ADDENDUM 2

CSP 22-68

Memorial Middle School Heating & Air Condition (HVAC) Improvements Funded through the Elementary & Secondary Emergency Relief (ESSER) Funds

April 8, 2022

1 LEVEL 1 MECHANICAL PLAN - D
 1/8" = 1'-0"

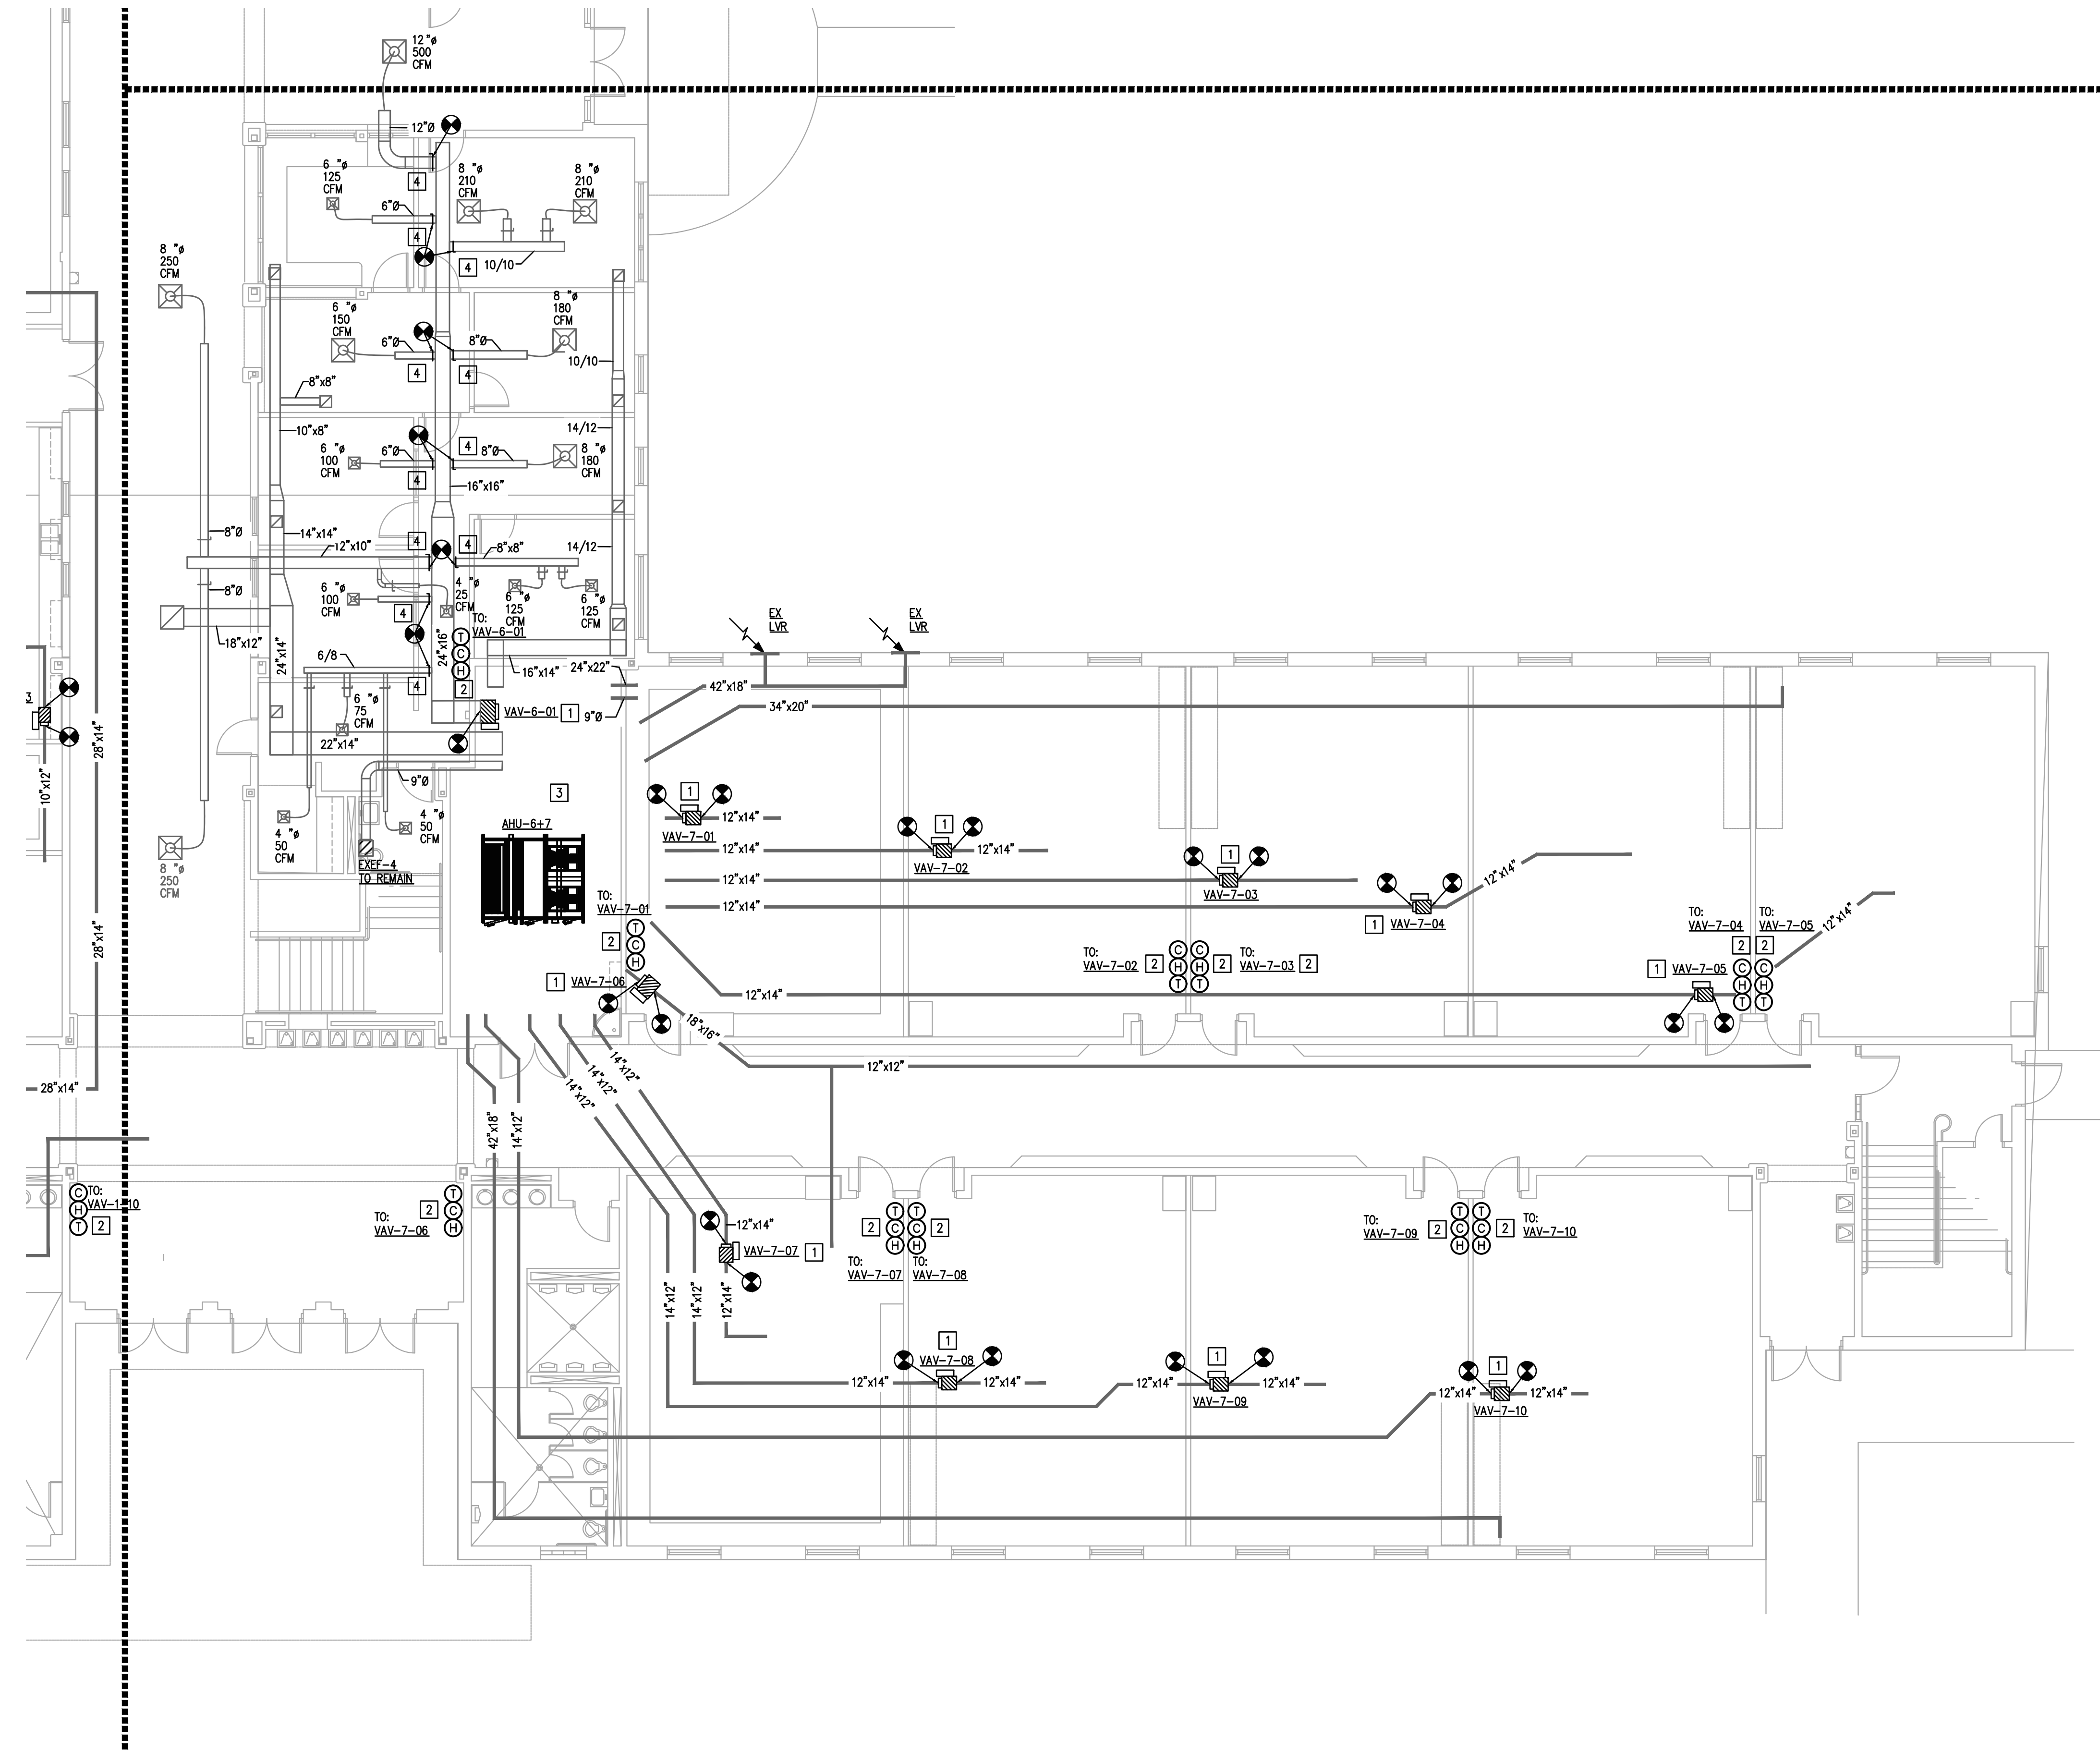
Item 11 SHEET M2.11D – LEVEL 1 MECHANICAL PLAN - D

A. Revised keyed note 1.

5 LEVEL 1C MECHANICAL AHU-4+5
 M3.10 1/4" = 1'-0"

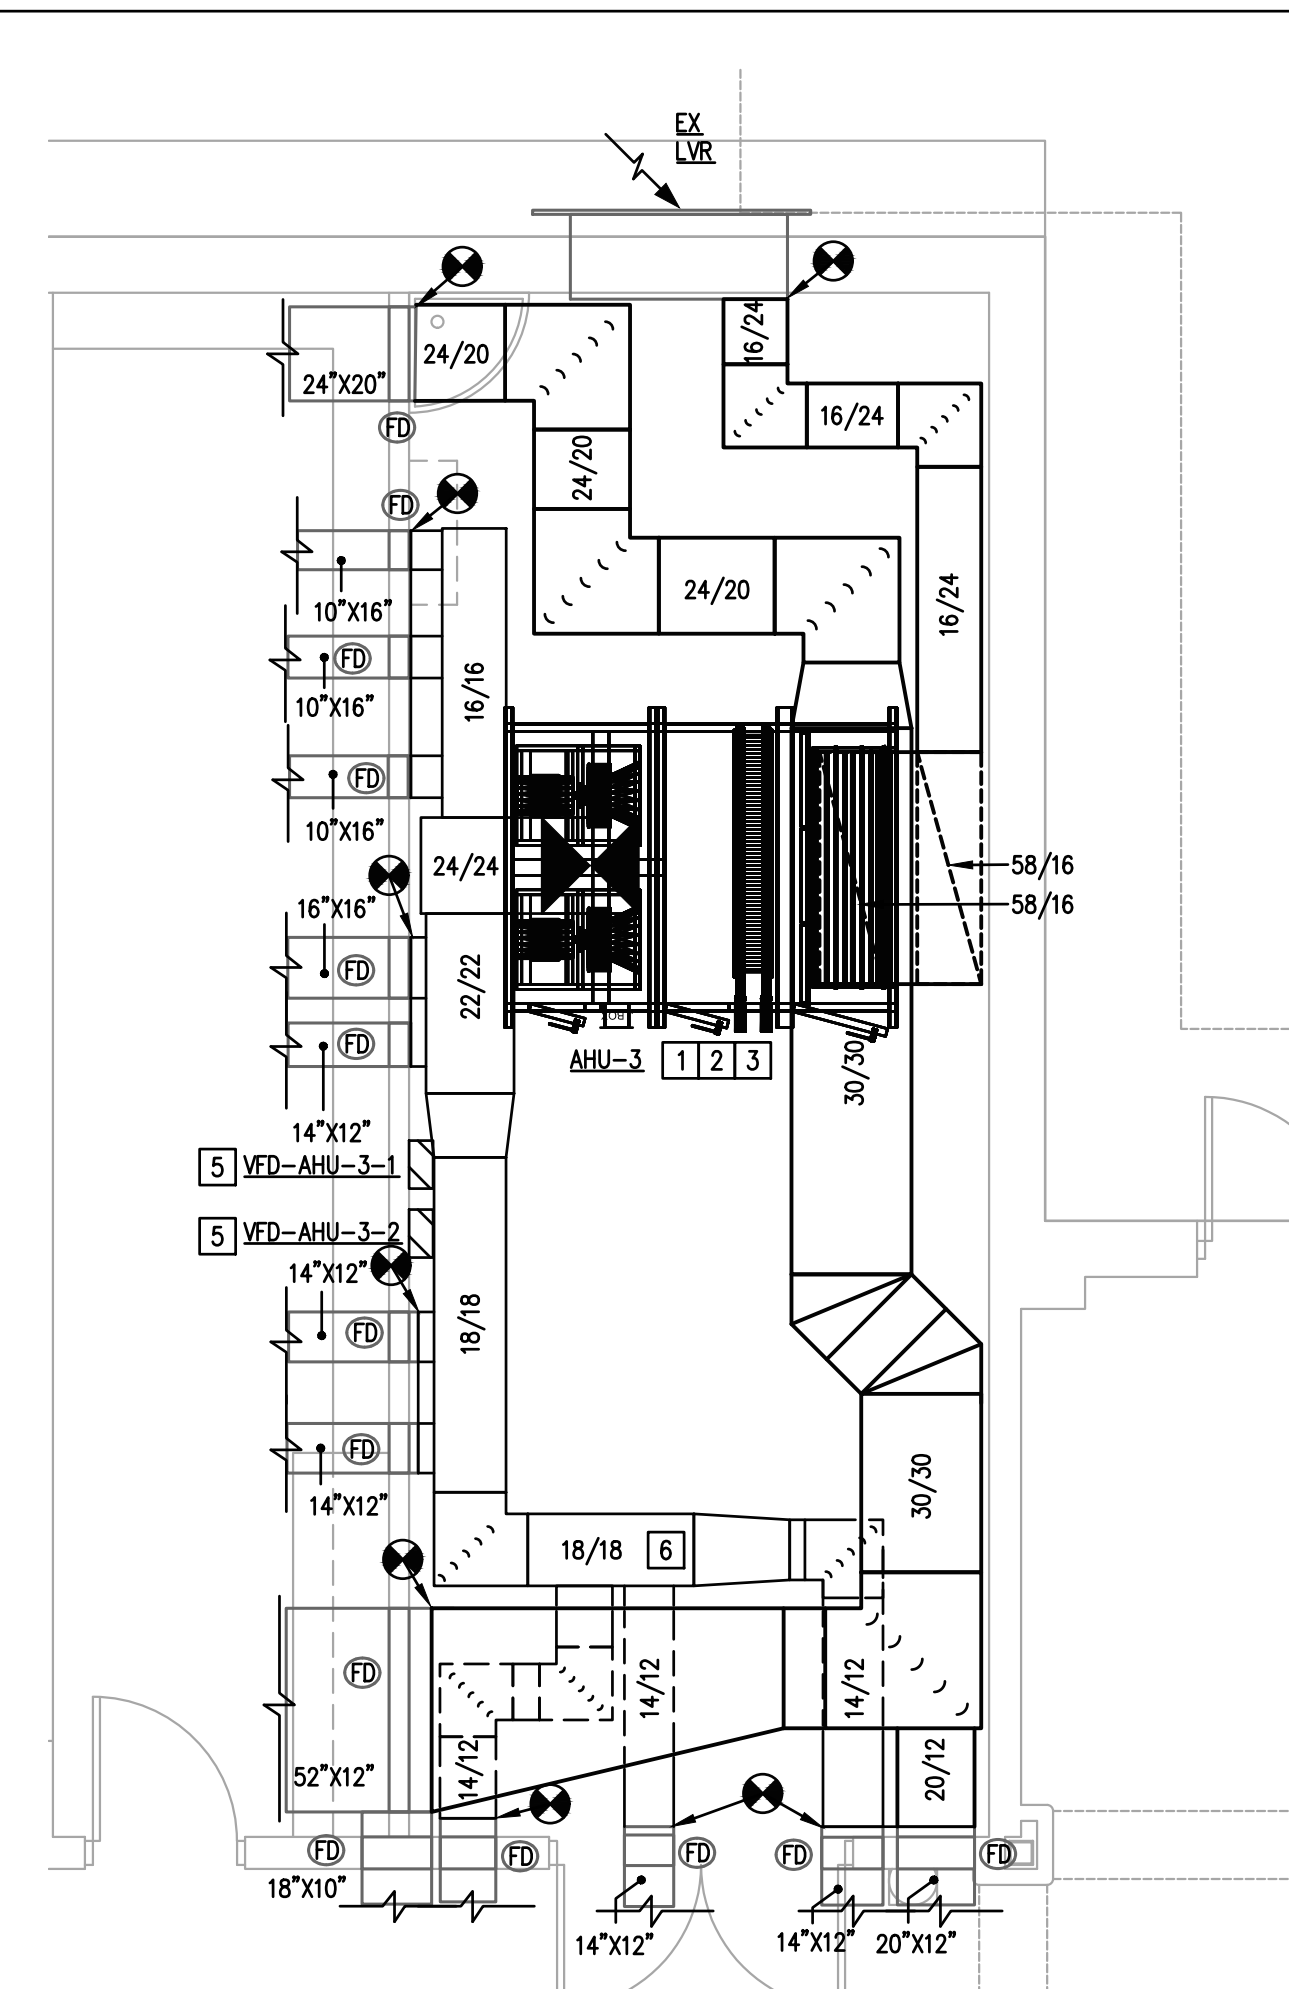
Item 12 SHEET M3.10 – ENLARGED MECHANICAL ROOM PLANS

A. Revised view of enlarged mechanical room plan #5.
